**CITY OF MERIDIAN
FINDINGS OF FACT, CONCLUSIONS OF LAW
AND DECISION & ORDER**

In the Matter of the Request for Annexation of 40.84 Acres of Land with an R-8 Zoning District; and Preliminary Plat Consisting of 172 Buildable Lots and 20 Common Lots on 38.56 Acres of Land in the R-8 Zoning District for Springday Subdivision, by Engineering Solutions, LLP.

Case No(s). H-2024-0069

SUBJECT: H-2024-0069
Springday Subdivision – AZ, PP

F. Common Driveway Exhibit (Lot 34C, Block 10) - REVISED

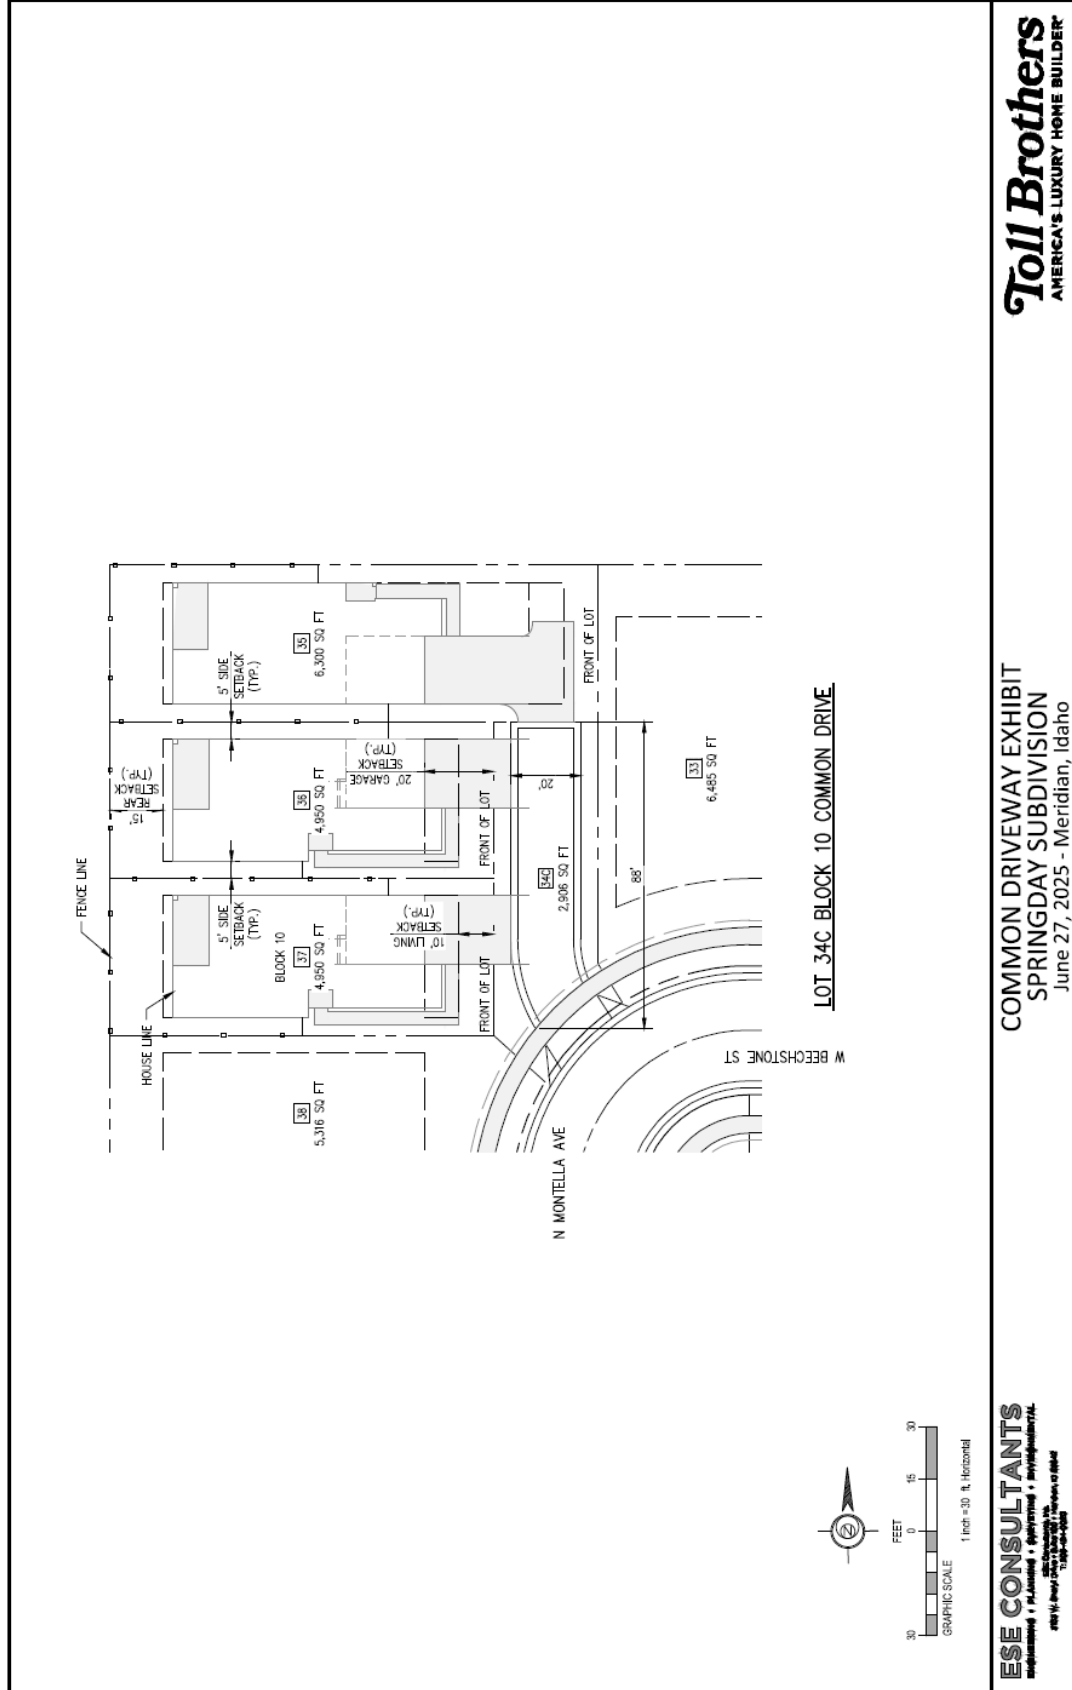
Two (2) common driveways are proposed; see exhibit in Section VII.F below. **All common driveways are required to comply with the standards in UDC 11-6C-3D, which require driveways to be a minimum 20' in width and no more than three (3) dwelling units may be located on one (1) side of the driveway. The plat depicts four (4) dwelling units on one side of each of the driveways and the paved surface of the driveways is below 20 feet. If solid fencing is proposed adjacent to common driveways, a minimum 5-foot wide landscape buffer planted with shrubs, lawn or other vegetative groundcover should be provided between the driveway and fence. The common driveway exhibits, preliminary plat and landscape plan should be revised to comply with these standards with submittal of the final plat application.**

6. Submit a revised common driveway exhibit that demonstrates compliance with the standards listed in UDC 11-6C-3D.

H. Qualified Open Space Exhibit (date: 3/6/2025)

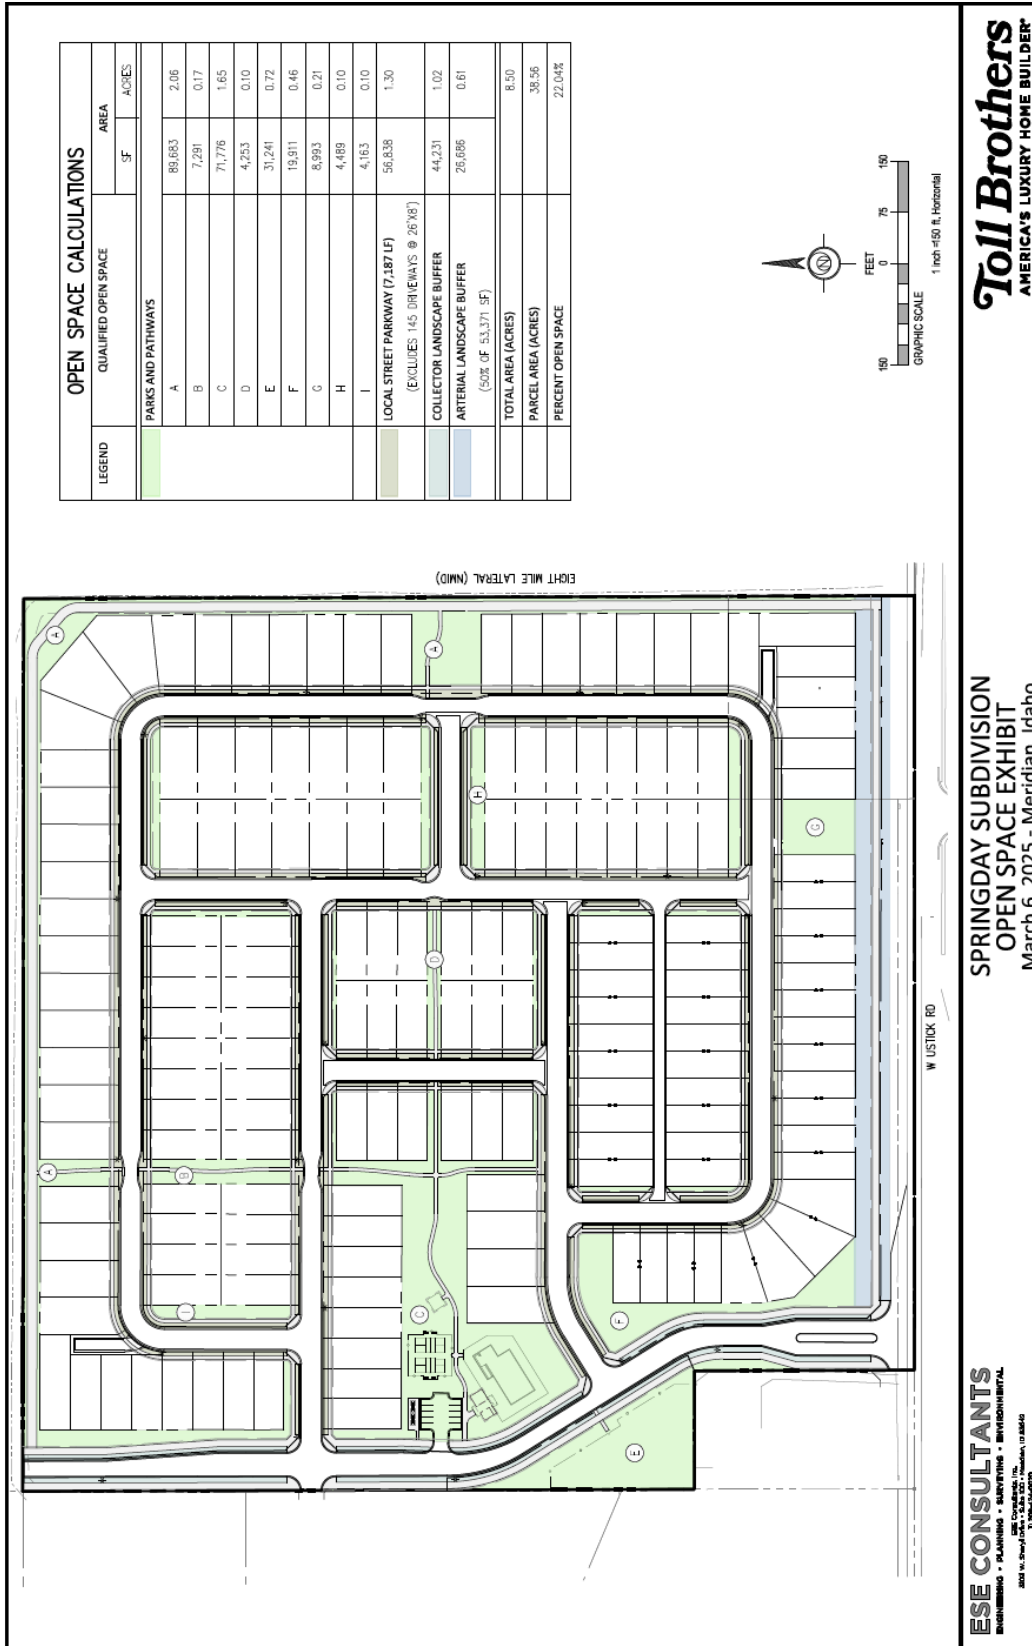
A minimum of 15% qualified open space is required to be provided with development. Based on 38.56 acres, a minimum of 5.78 acres is required; 8.50 acres (or 22.04%) is proposed that meets the quality standards in UDC 11-3G-3A.2 (see exhibit in Section VII.H below).
